27 July 2015

**Letter of objection to Staged Concept Proposal SSD 6454– SCEGGS Redlands 272 Military Road, Cremorne (Proposal)
Unit 1/19 Waters Street Neutral Bay NSW (Property)**

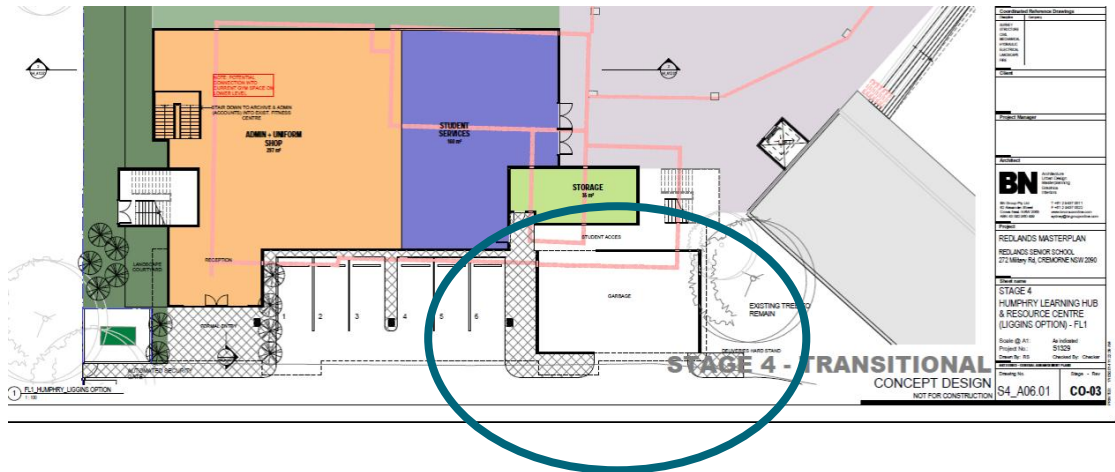
15. The diagram below extracted from the application plans shows a large garbage area within or adjacent to the Humphrey building and demonstrates that access to the garbage area for the Proposal is directly adjacent to our client's property (though notably the adjacent residences are not shown on the plan). This will result in garbage trucks using the access lane on a weekly or daily basis, which is both noisy and potentially smelly, and strongly objected to by our client.

16. The large garbage area is proposed to be located directly adjacent to the backyards of the residential properties, off the access handle.
17. Our client's only private open space, lounge room and bedroom all face onto the proposed access handle. This means that our client and other residents will be subjected to the noise and smell of regular garbage truck movements.
18. The location of the access handle and garbage room are completely inappropriate, and push the unacceptable impacts of noise, traffic and garbage trucks onto the neighbouring residences, rather than containing these impacts internally within the development.
